JOB NAME: WESTFORK CROSSING LOT 7

DETAILS OF: CMU WALL REINFORCEMENT DETAILS DATE: 08-15-22

TEXAS REBAR, LLC 817-487-1672

DUMPSTER CMU WALL LAYOUT
 REF: S1.03, S2.01, S3.01 & A2.03 (DT.04/08/20)
 SCALE: 1/4" = 1'-0"

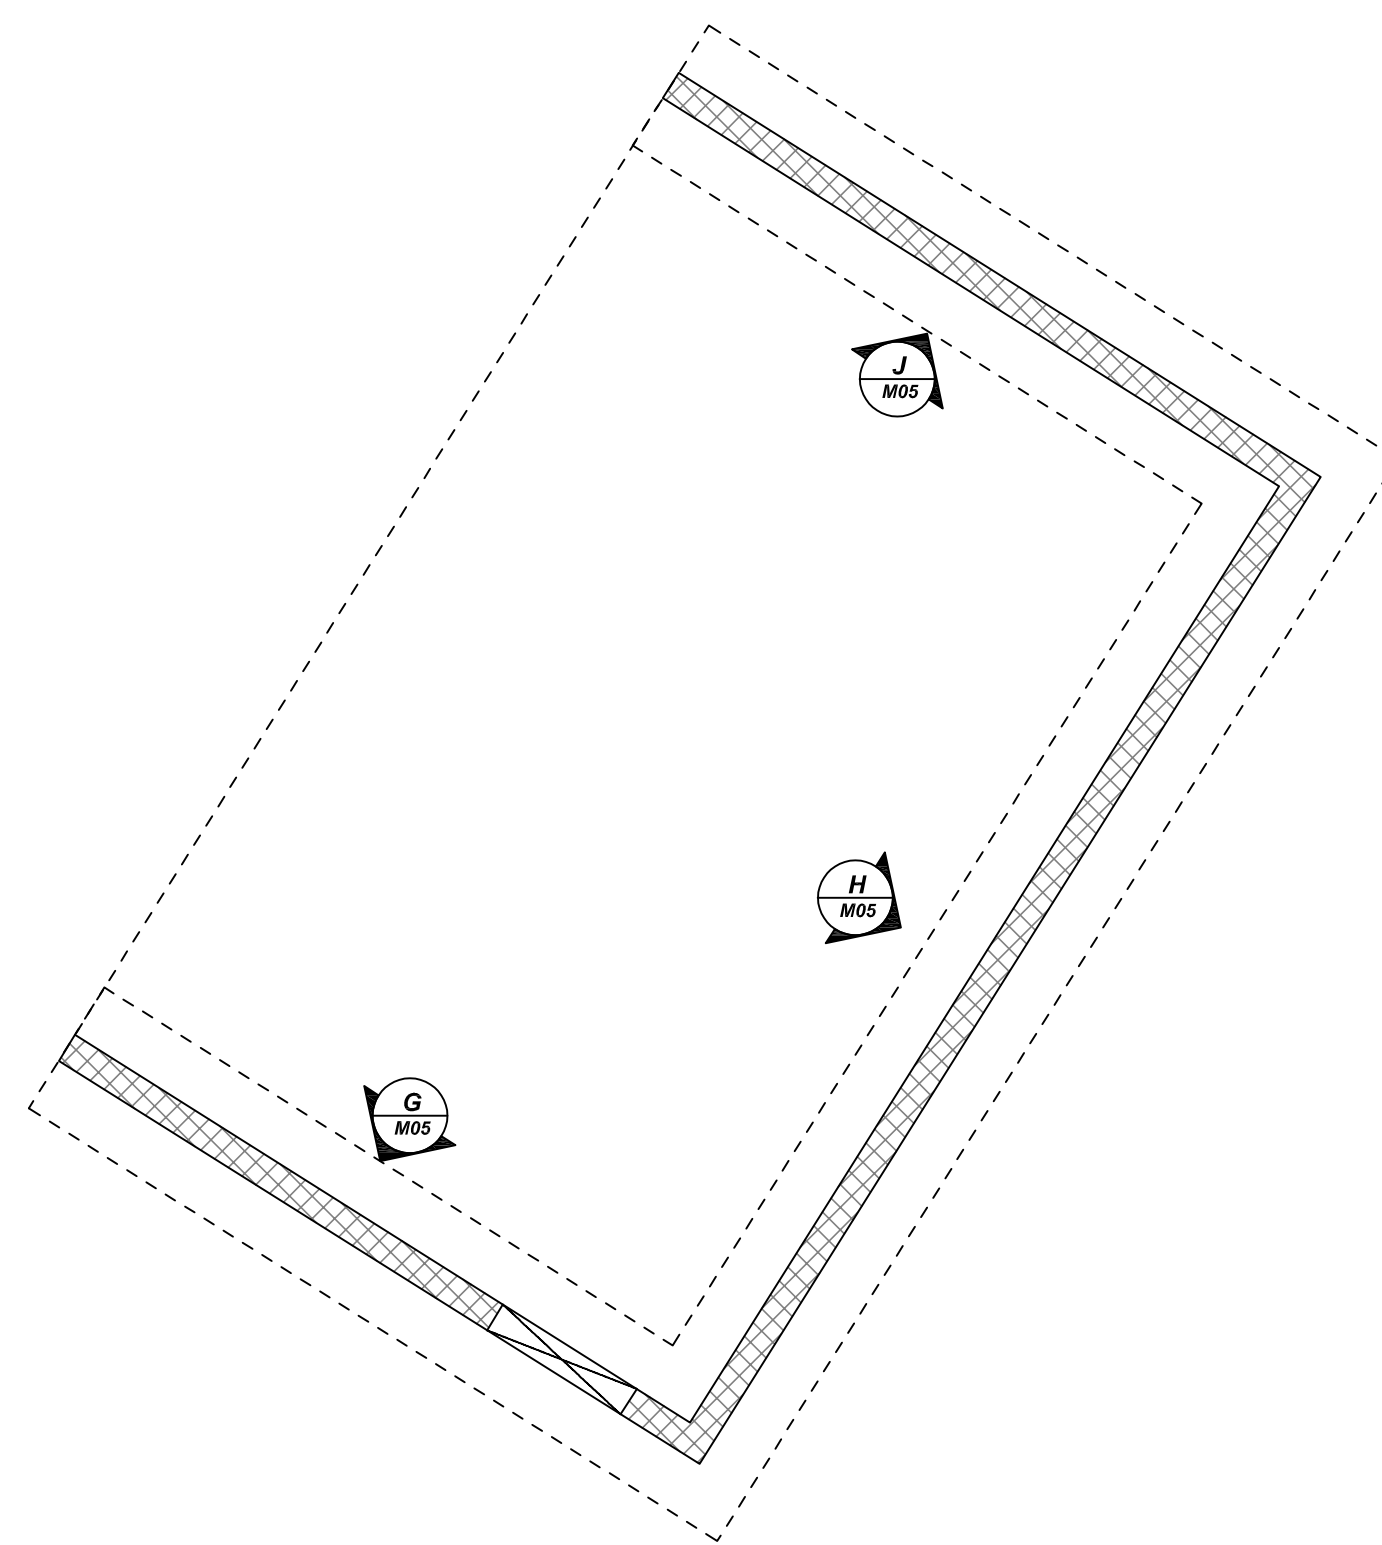
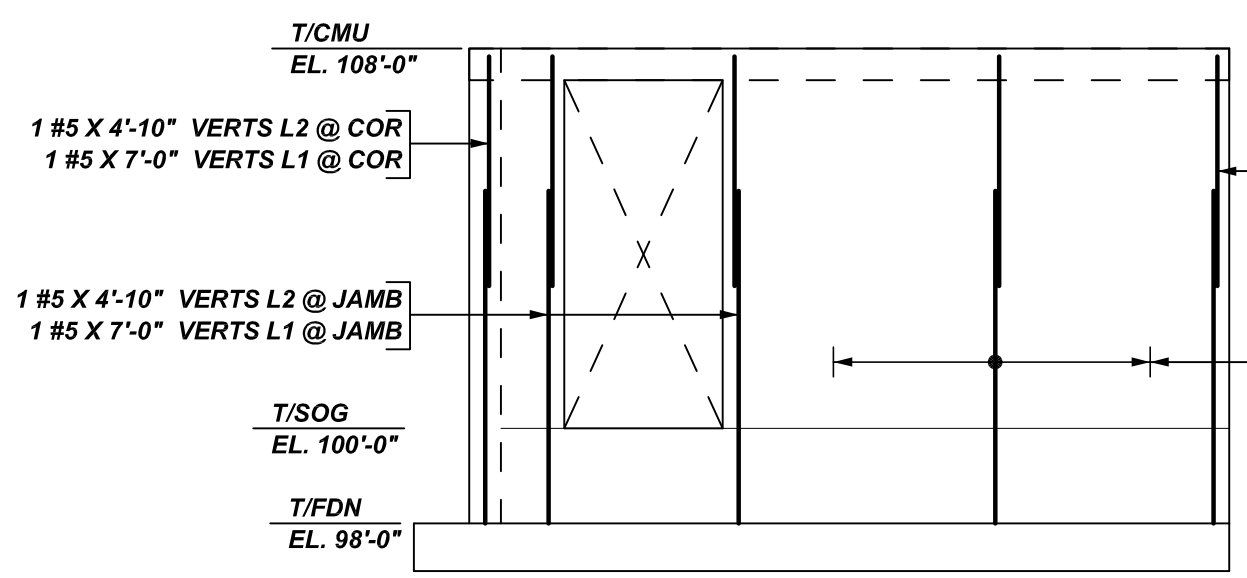
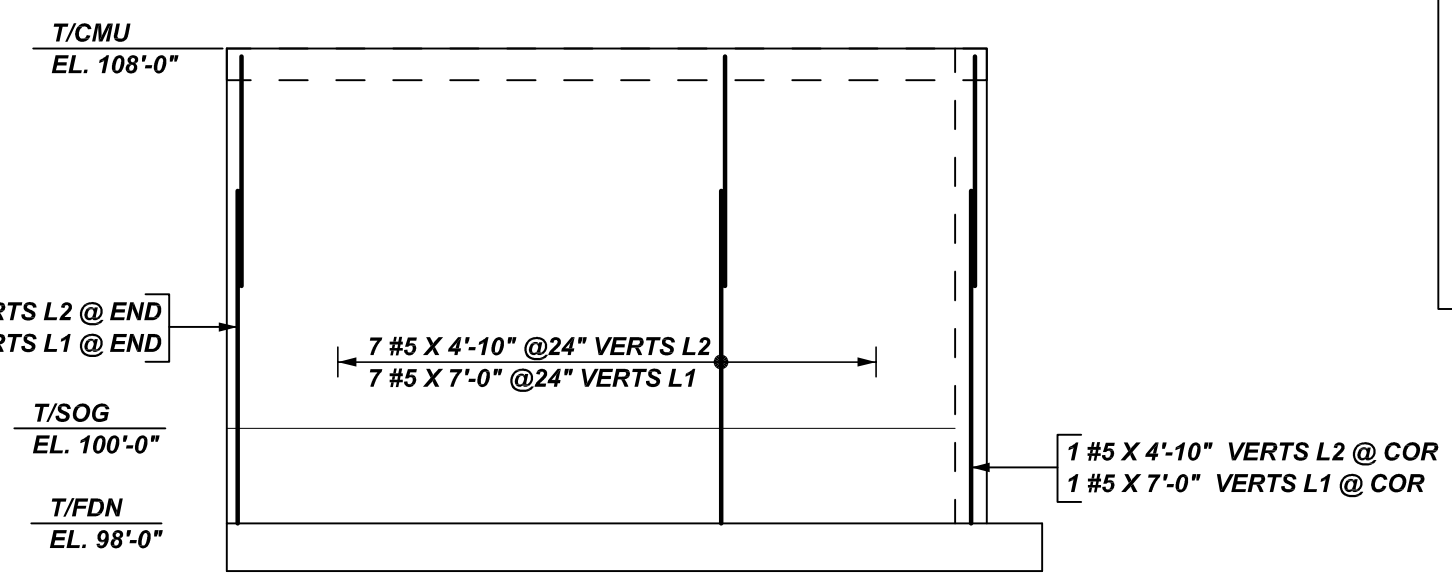
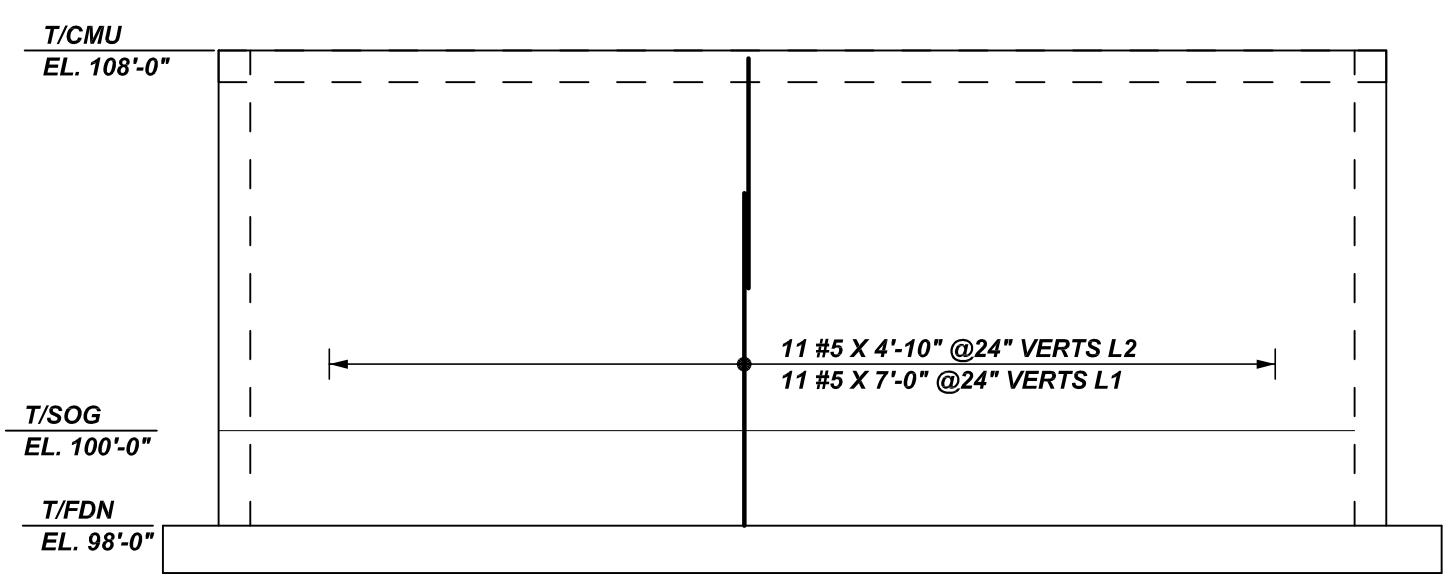
A/E PLEASE VERIFY NORTH DIRECTION
